# **Fujitsu M10/SPARC M10 Systems**

Product Notes for XCP Version 2042

Manual Code: C120-E699-02EN  
October 2013

Figure 8-1      Tabs and pull-out directions of crossbar cables

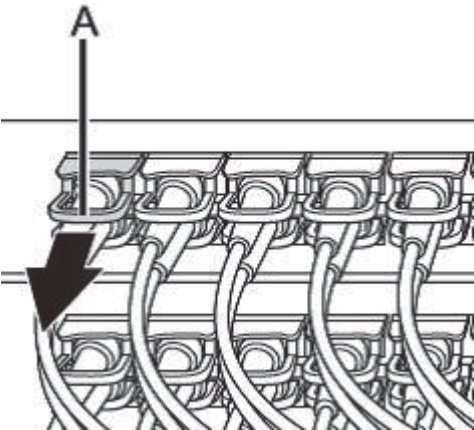
Section number or name	Contents of revision
4.3.1	Steps 2 and 3 described in "4.3.1 Changing crossbar cable (case in which the expansion rack 2 is added later)" will be changed. For details, see " <a href="#">Changing crossbar cable (case in which the expansion rack 2 is added later)</a> ."

2. **Move the crossbar cable (optical) for XBBOX#80/#81.**
  - a. **Remove the crossbar cables between L4 and L7 and between R4 and R7 of the crossbar unit #1.**

Hold the tab (A in Figure 8-1) of the crossbar cable (optical), and pull it straight in the arrow direction to remove it. At this time, do not pull out the crossbar cable by holding the cable part. If you pull the cable part, the connector is not unlocked completely, which may cause a damage.
  - b. **Reattach the labels of the removed cables.**

Figure 8-4 Location of cable guide

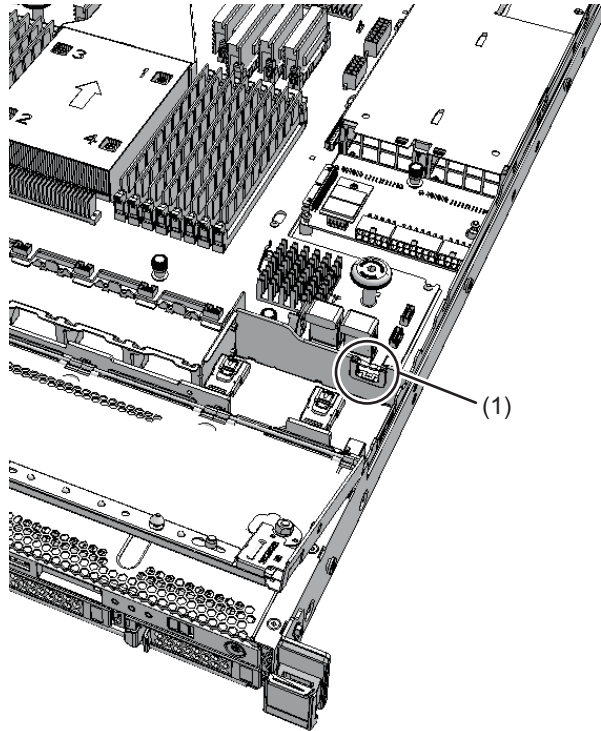
7.5.1	<p>Procedure to store cables in the cable guide will be added to Step 6 in "7.5.1 Installing motherboard unit." For details, see "<a href="#">Storing Cables in Cable Guide</a>."</p>
Chapter 16	<p>"Chapter 16 Maintaining Cable Kit" will be added. For details, see "<a href="#">Appendix A Maintaining SPARC M10-1 Cable Kit</a>."</p>

6. **Store cables of the motherboard unit in the cable guide.**

Figure 8-5 Storing cable (red/black)

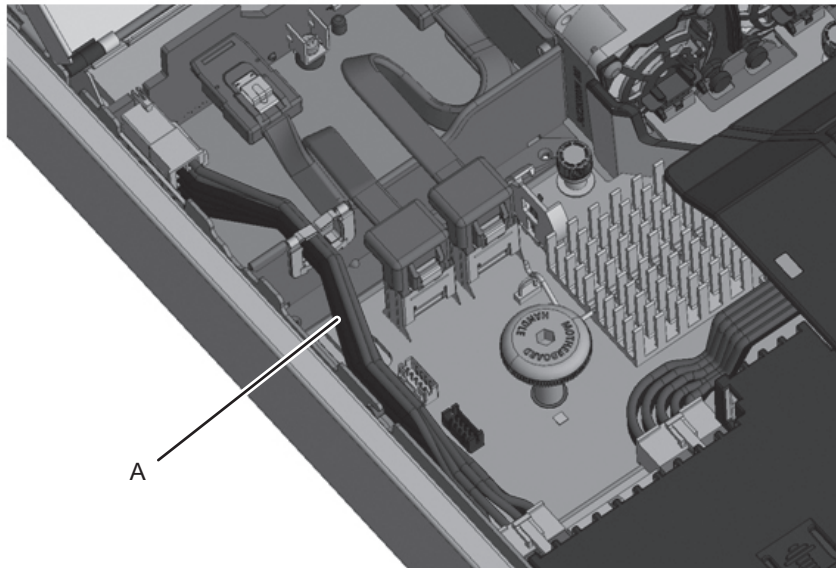
- a. **Store the cable (red/black) (A in the figure) connecting the HDD backplane to the PSU backplane in the cable guide from the middle of the clamp.**

Figure 8-8 Cross section of the guide viewed from the front, after storage of the cables

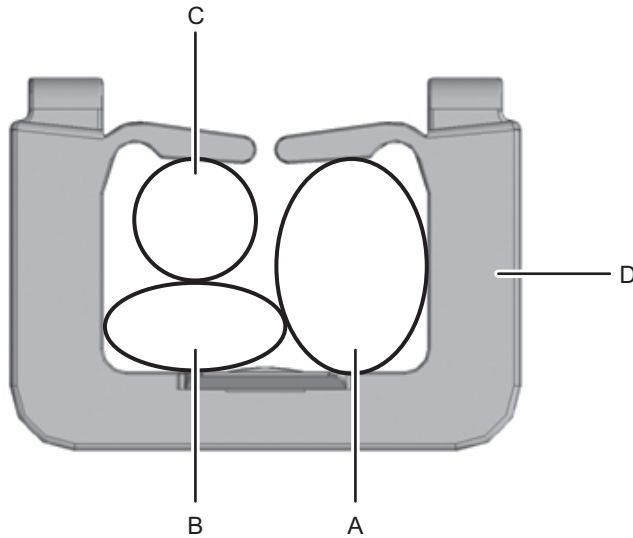
- d. Confirm that each cable is stored in the cable guide, as shown in Figure 8-8.
